**RE: Planning permission for development @ Tig Mhuire, Old Bridge Road, Templeogue, D16, D16W6F4 -SD21B/0589 Brian and Lauren Monaghan-Clarification of Additional Information dated 14/02/2022.**

**Additional information request-Section 1. Storm Water**

**Additional information request-Section 2. Foul Pump Station**

Fig 5. Proposed Location of new FPS

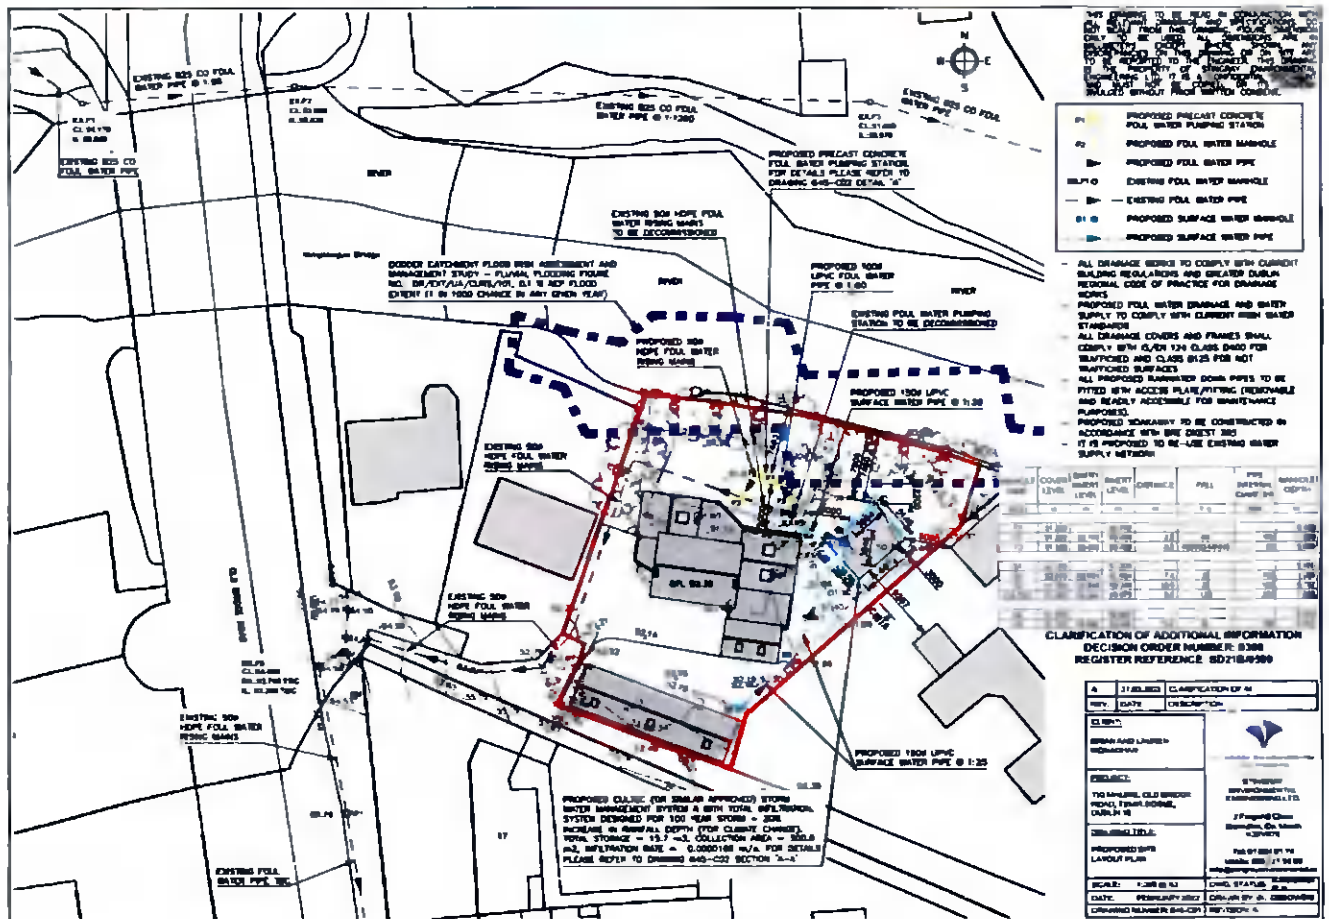
*The proposed pumping station must be a minimum of 5m from the existing house and outside of any existing flood zone according to OPW (Office Public Works) CFRAM flood mapping.*

Proposed location of FPS is to meet required setbacks as tabulated below.

Features	Required	Proposed Foul Pumping Station
Existing Flood Zone OPW	Outside zone	FPS located outside 1:1000year flood zone
Building/Structure	5m	5m FPS to existing/proposed dwelling
SUDS system	5m	>5m FPS to Cultec Storm system
Site Boundary	3m	>3m FPS to site boundary
Watercourse	10m	7.5m FPS to river Dodder- top of the bank*

Fig 2. Separation distances. \* Due to site space restrictions, the minimum recommended separation distance cannot be met. We are looking for an exception due to the following reasons:

- The proposed underground FPS uses watertight reinforced plastic or precast concrete vessel with 24hrs emergency storage capacity thus reducing a risk of overflowing and minimizing the potential pollution to surface water during the hypothetical FPS breakdown
- The proposed underground FPS would replace an existing FPS that is in the same area that also does not meet the setbacks that are now required
- While the distance from the proposed underground FPS to the site boundary (River Dodder top of the bank) is only 7.5 metres, it is another approx. 5-6 metres from the site boundary to the normal flowing of the River Dodder. See images of the site boundary and the river Dodder with the distance between them.

Fig 6. Proposed FPS

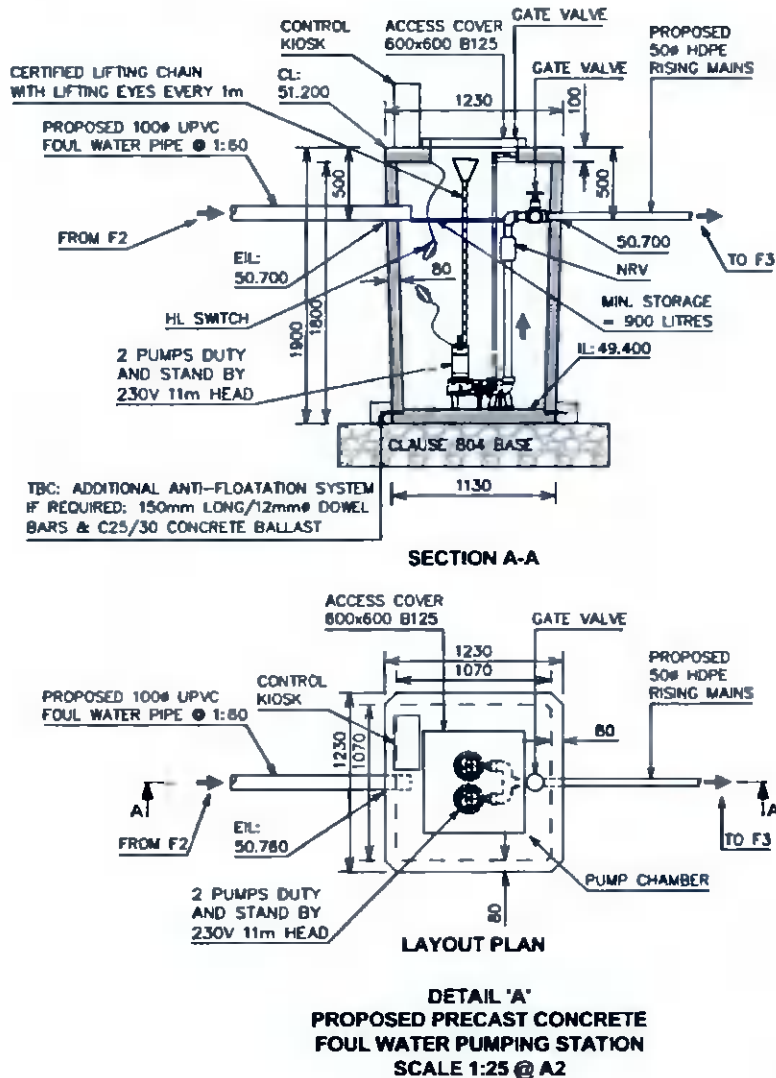
*The proposed pumping system shall include a duty standby pumping arrangement with the inclusion of 2 pumps*

Proposed FPS to contain twin pump system with Duty Standby arrangement.
